## Hot Water Utilidor Project MAJ 15-MJ0065-Rebid

### Questions and Responses #1

**DATE:** October 14, 2016

**PROJECT 5227**  
(see Sheets MD17.0 & M17.0)

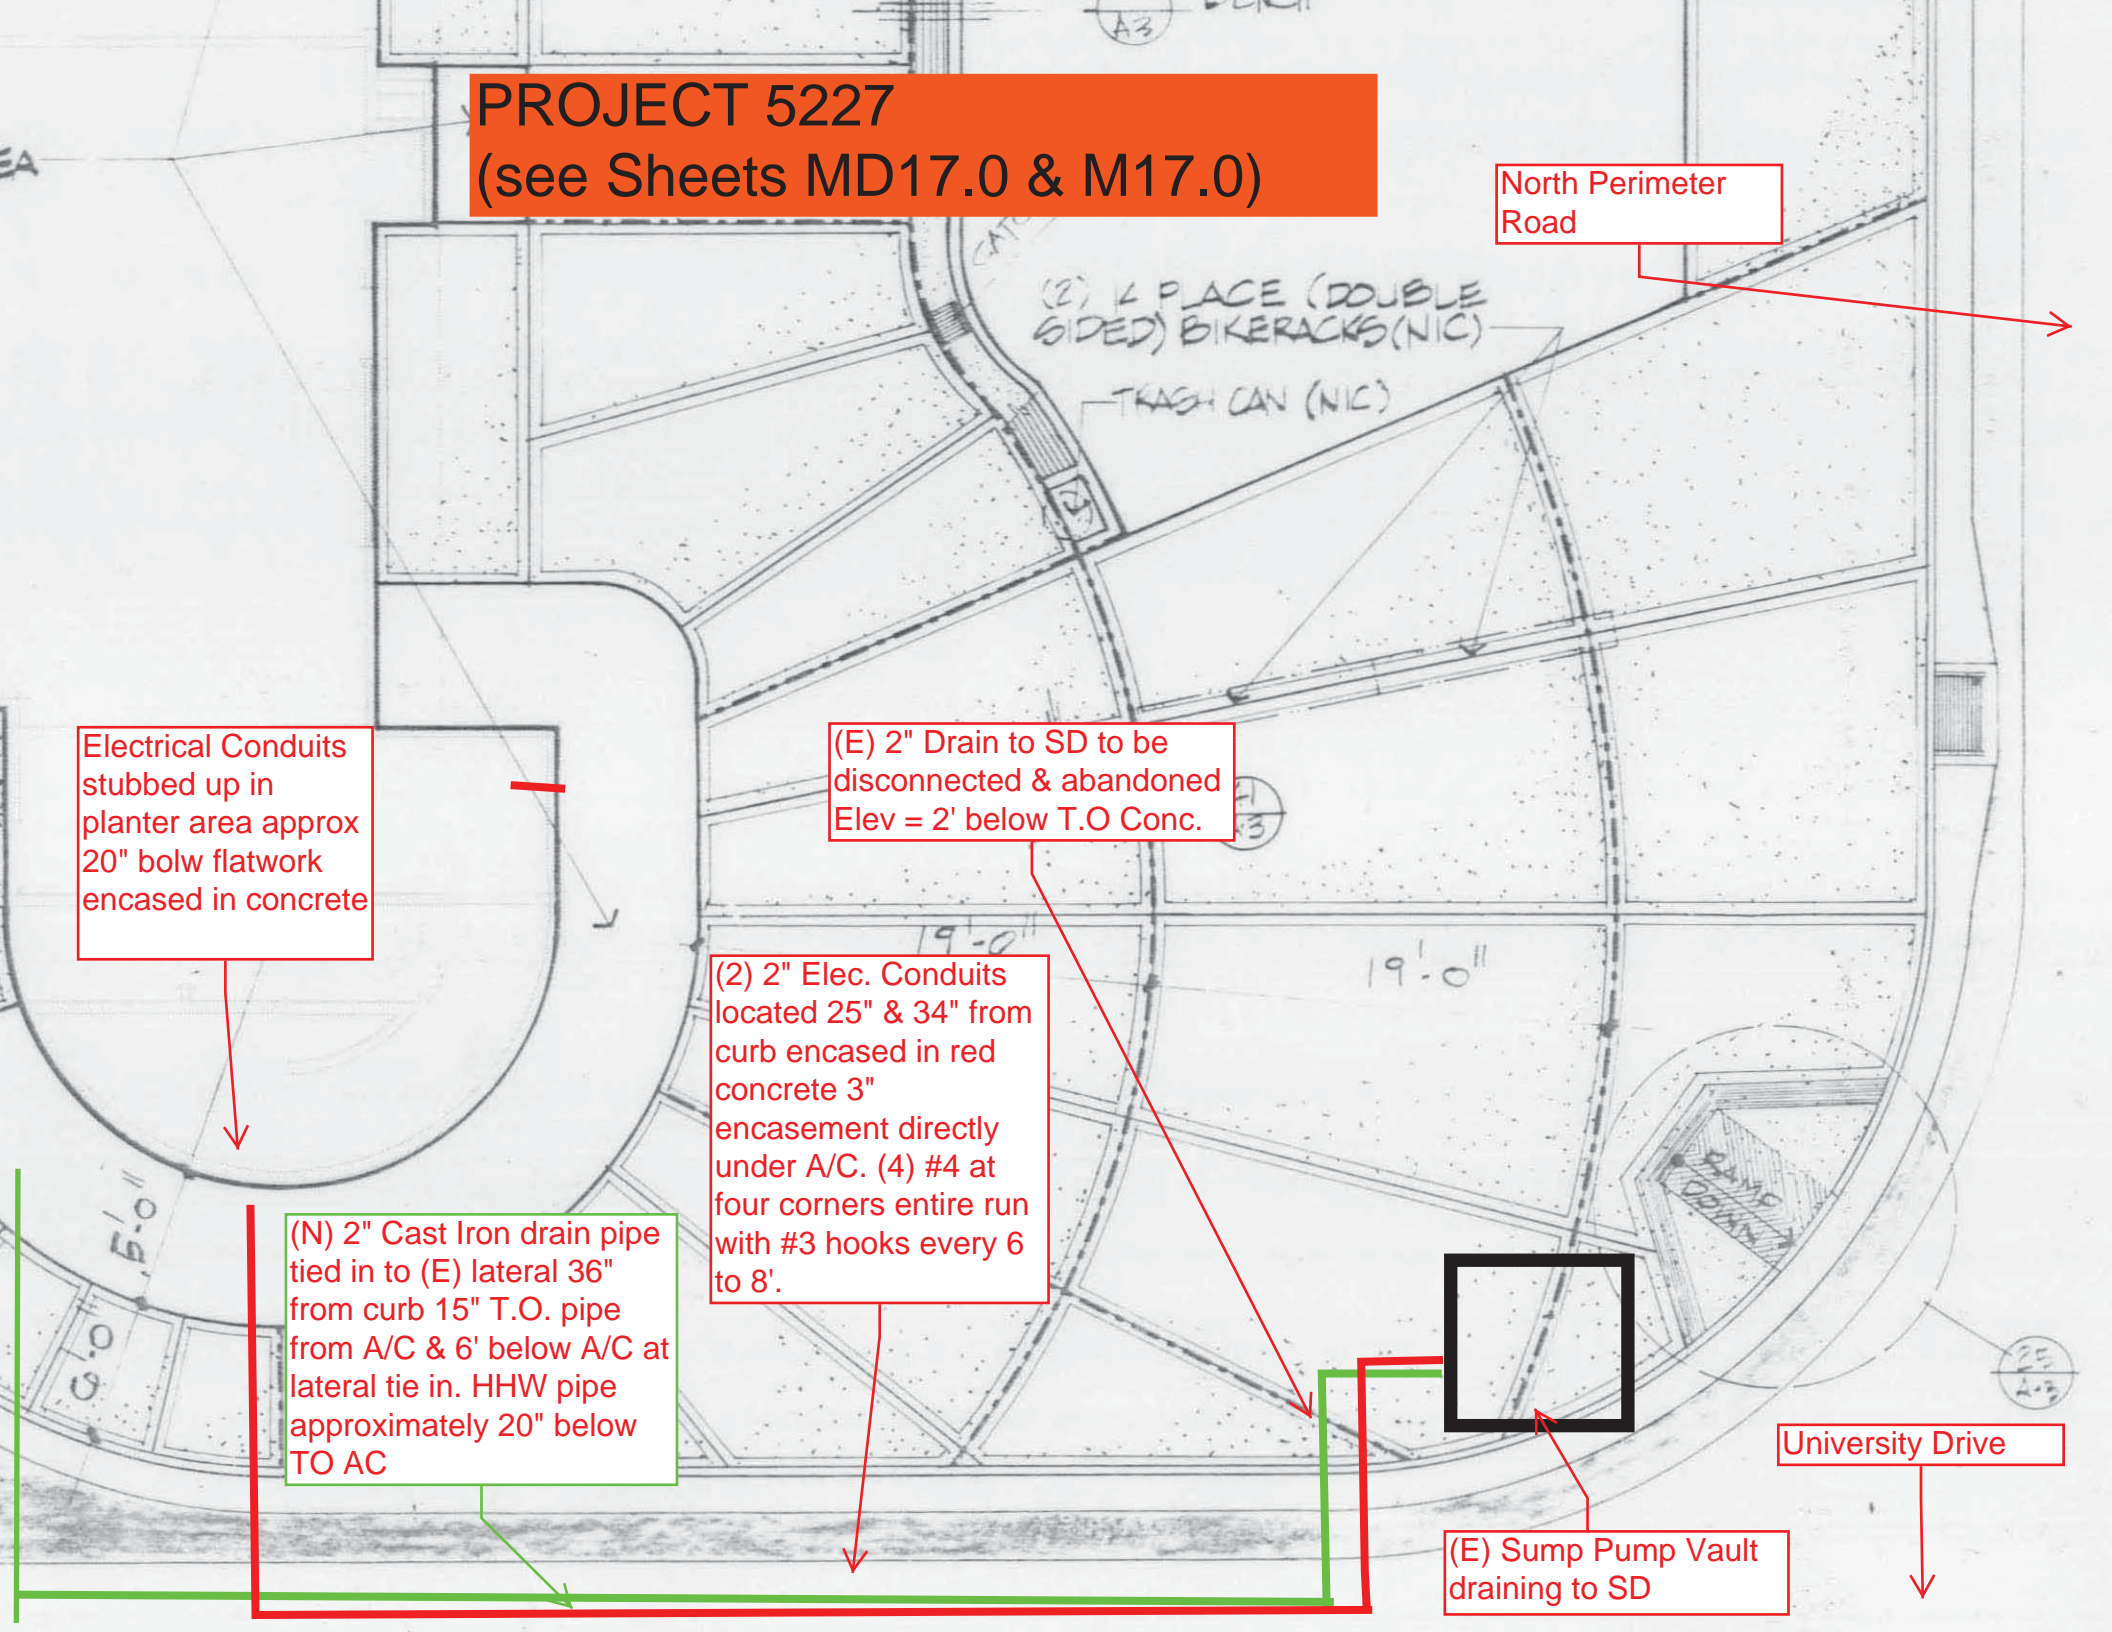
1. Due to the high quantity of underground utilities throughout campus, our "Cal Poly Utility Atlas" is attached which shows all known underground utilities. Many of the dry utilities have slurry backfill. All Bidders shall consider the Atlas Map and project Drawings together to understand underground utilities at each work location. During the project, underground utilities will be marked with paint in the field prior to construction before excavation begins.
2. A recent summer 2016 project that occurred at University Drive & N. Perimeter added electrical underground utilities in this area. The "Project 5227" as-built drawing is attached for reference and shall be taken into consideration for the work to be conducted in this area. These As-Built Drawings have not been added into the Atlas yet.
